Project Name: **SouthGlenn Redevelopment**

CASE NAME: The Streets at SouthGlenn Master Development Plan, 8 th Amendment
CASE NUMBER: PUD-21-00004
DATE OF REFERRAL: 7/21/2021
DATE TO BE RETURNED: 8/13/2021

**Re: The Streets at SouthGlenn Master Development Plan, 8th Amendment
Case # PUD-21-00004**

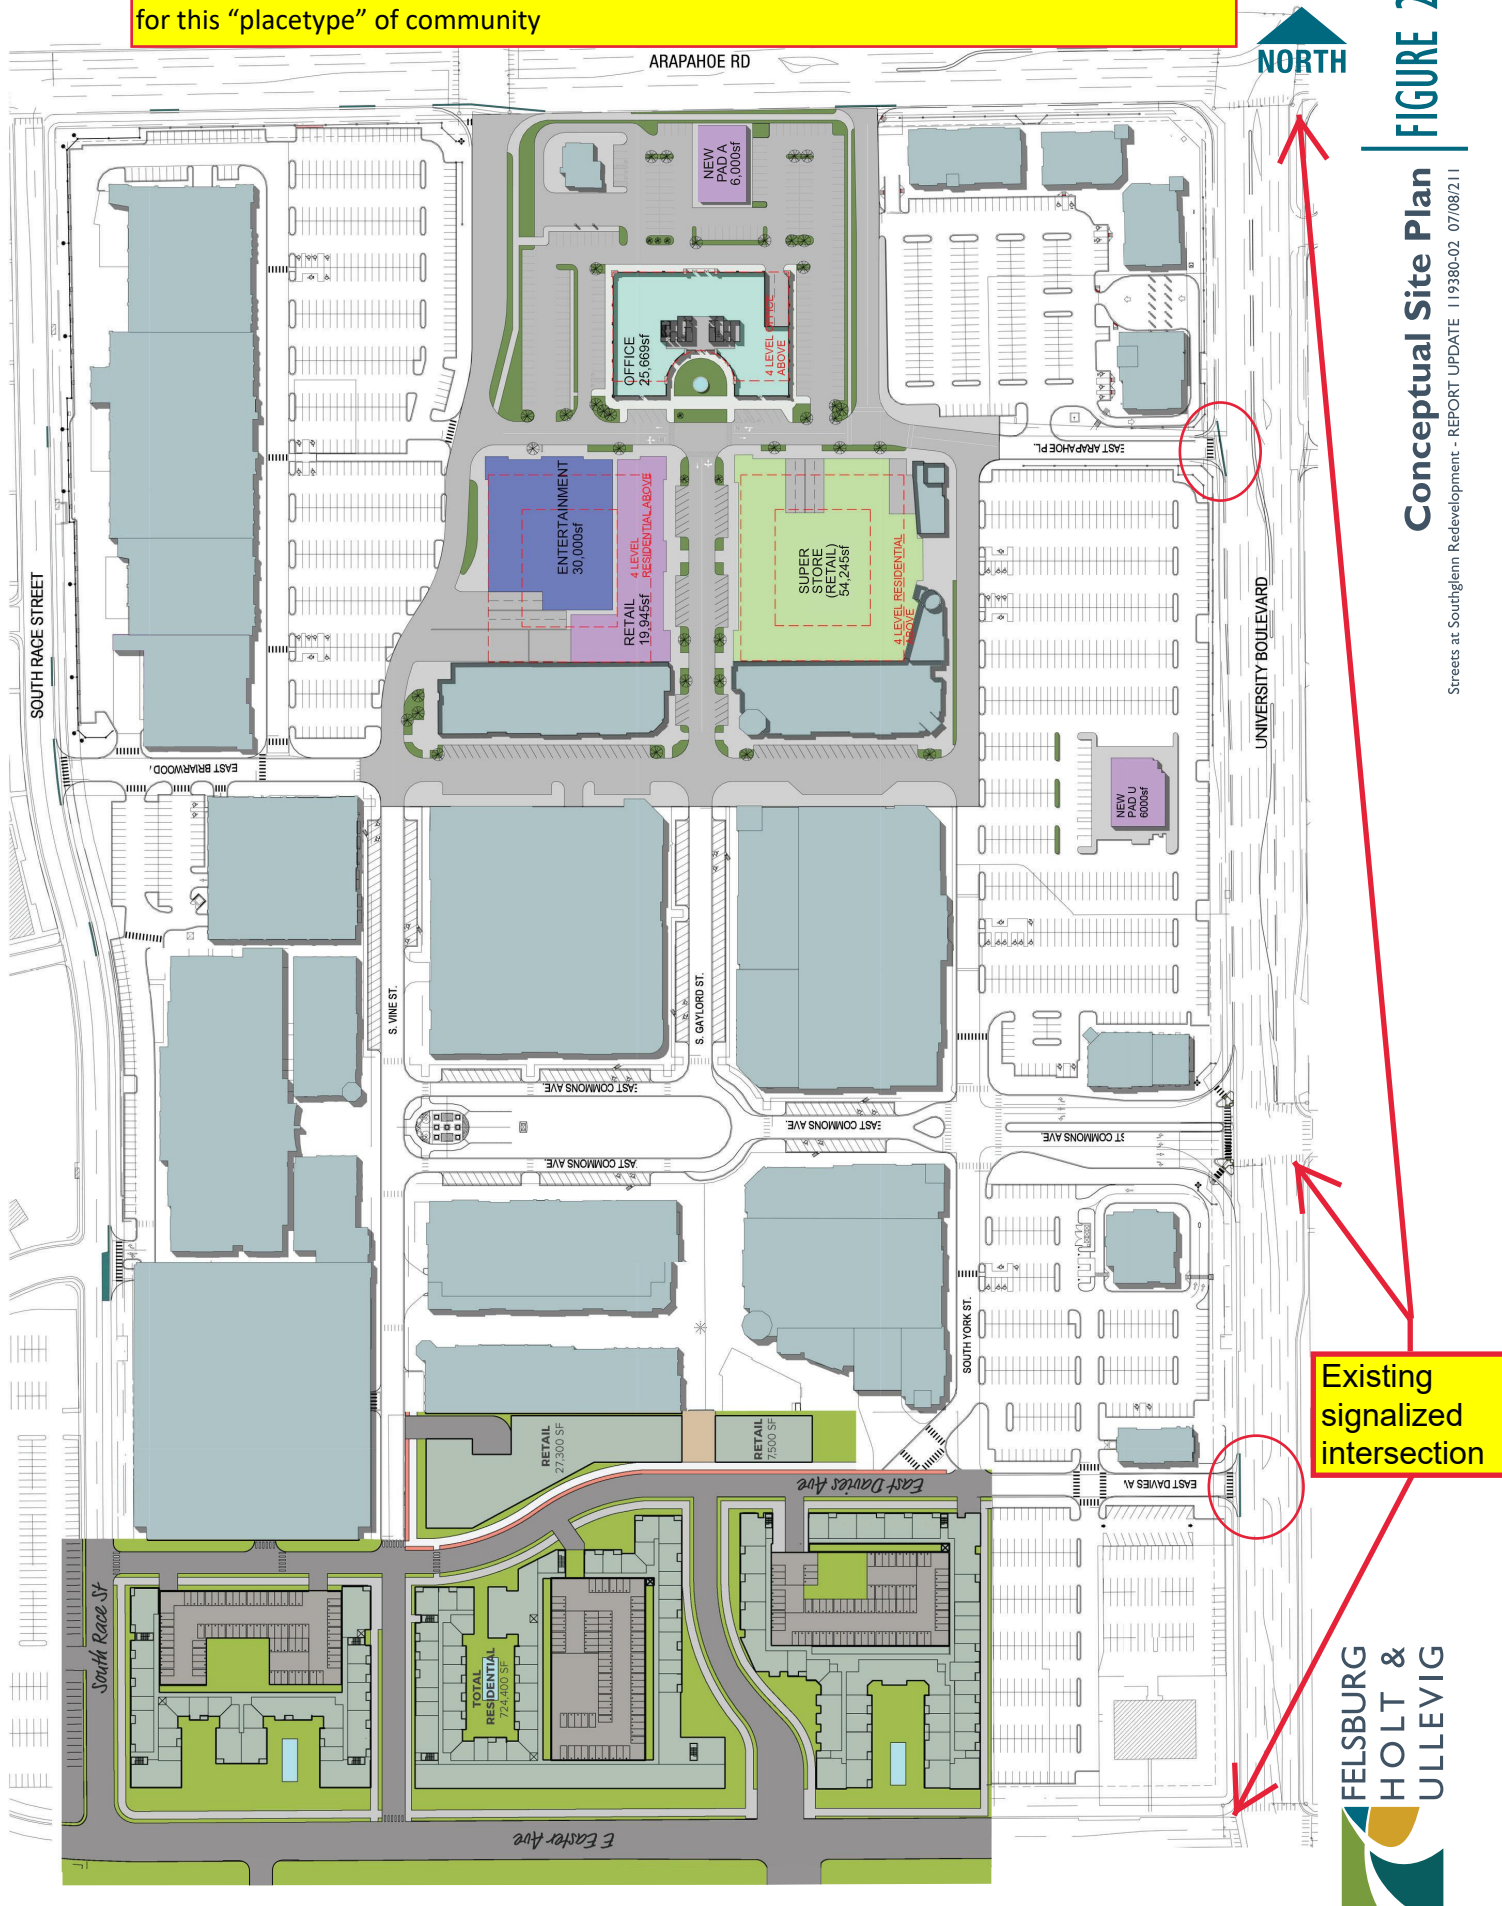
A higher degree of pedestrian traffic crossing SH 121 should be anticipated. Not all pedestrian crossings are ID in the study and as recommended, a TDM component should be prepared for this “placetype” of community.

These are all
CDOT RoW
accesses

This = access permitting (or SUP)
